Contract #: 04-0120F4Cty: SF/ALA Rte: 80 PM: 13.2/13.9File #: 69.25B**QUALITY ASSURANCE -- NON-CONFORMANCE REPORT****Location:** Changxing Island, Shanghai, P.R. China**Report No:** NCR-000389**Prime Contractor:** American Bridge/Fluor Enterprises, a JV**Date:** 24-Aug-2009**Submitting Contractor:** Zhenhua Port Machinery Company, Ltd (ZPMC), Changxing Island**NCR #:** ZPMC-0363**Type of problem:**

Reference Description: Missed UT indications by QC on 1AW/1BW Segment Transverse Splice**Description of Non-Conformance:**

Job Name: SAS Superstructure

Subject: NCR No. ZPMC-0363

Component: 1AW to 1BW Weld #OBW1A-007

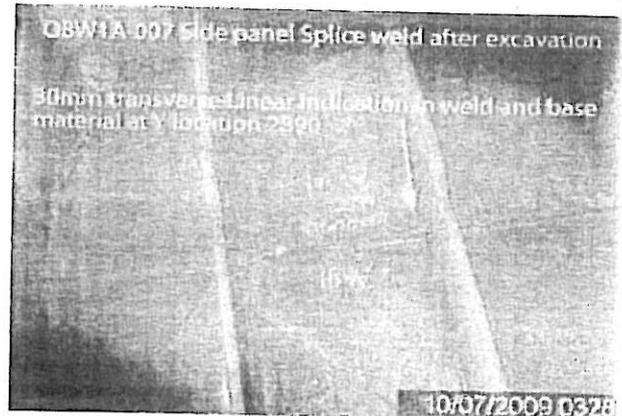
During a random visual observation of ZPMC personnel performing air carbon arc gouging of segment 1AW to 1BW Side Panel transverse splice weld OBW1A-007 at the Counterweight side, the Caltrans Quality Assurance (QA) inspector observed ZPMC was performing this repair utilizing the weld repair report (B-WR8086). This weld repair report did not describe any magnetic particle testing (MT) verifications in the excavation prior to re-welding nor after the completion of welding to ensure that the joint is free of defects. The QA Inspector had the opportunity to perform MT after air carbon arc gouging and observed numerous transverse cracks present ranging from 2 mm to 30 mm in length. No Critical Weld Repair Report was obtained for this weld repair.

The Y locations and the number of Transverse Cracks observed in weld # OBW1A-007:

- 1) Y=50~2475mm, (14) Transverse Cracks
- 2) Y=2720~5030mm, (29) Transverse Cracks

Component: 1AAW to 1AW Deck Panel Weld Splice OBW1-001

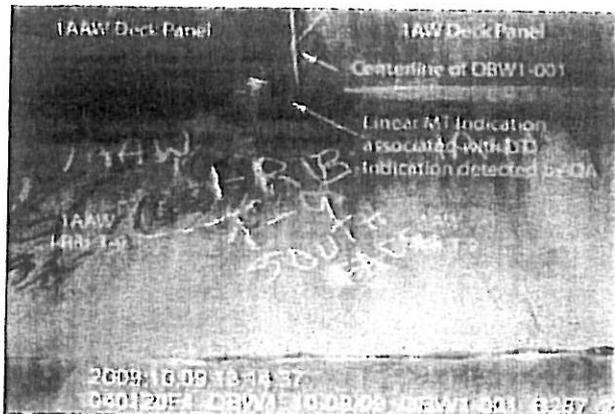
The QA inspector discovered one (1) class "A" rejectable Longitudinal Linear indication in the OBW1-001 (deck panel) weld. This weld was previously tested and accepted by the contractor. This acceptance by the contractor is evident by the presence of the contractor's distinguishing mark indicating QC acceptance. The QA inspector was also able to verify this UT longitudinal indication by magnetic particle (MT) testing from the interior side of the splice weld.

NOTE: The Y location of the Class "A" rejectable Longitudinal Linear Crack is at 5310-5340mm measured from Point W1, or 19750-19780mm if measured from W6. This indication is identified as #25 on ZPMC UT Report B787-UT-8548-1 associated with B-WR7867. The QA inspector verified a 40mm Magnetic Particle (MT) Linear Crack from the interior surface that is associated with Class "A" UT" Rejectable Indication mentioned above.

Component: 1AW to 1AAW Side Panel Splice Weld OBW1A-00

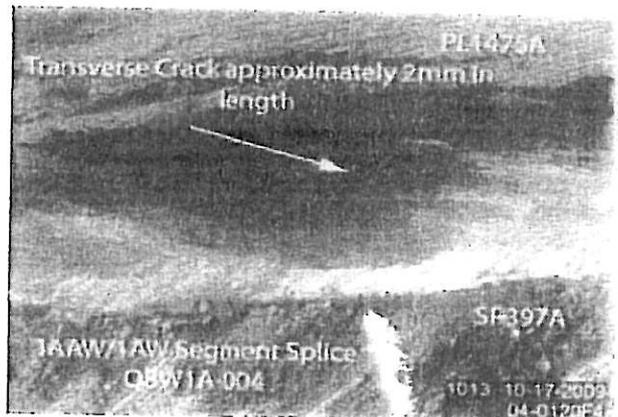
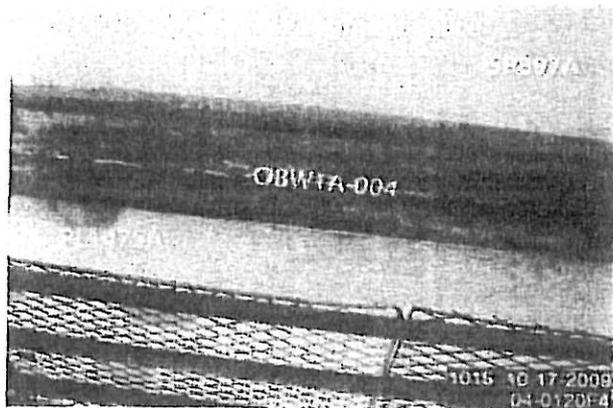
During random visual inspection the QA Inspector performed Magnetic Particle Testing (MT) of an Ultrasonic Testing (UT) reject excavation in the segment CJP Side Plate splice (OBW1A-004), cross beam side joining SP397A (1AW) and PL1475A (1AAW). During this verification the QA Inspector discovered three (3) Transverse Cracks in the excavation. One (1) 2 mm crack was located at Y location 1945mm and two (2) 1mm cracks at Y location 2785mm from the cross beam side Edge Plate.
